MERCURY PERFORMANCE OUTBOARDS

service bulletin

No. 97-1

Piston Pin Retaining Clip Change

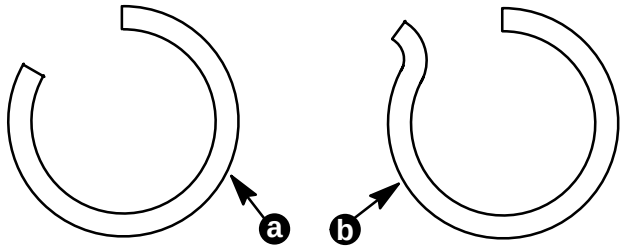
This new retaining clip can be used in pistons which have the notch for the bent end retaining clip, and can be used in conjunction with or to replace the old style bent end retaining clips.

The bent end retaining clips that required a notch in the piston cannot be used in new style pistons which do not have the notch.

a - New Retaining Clip P/N 53-821246-1
b - Old Retaining Clip P/N 53-821246
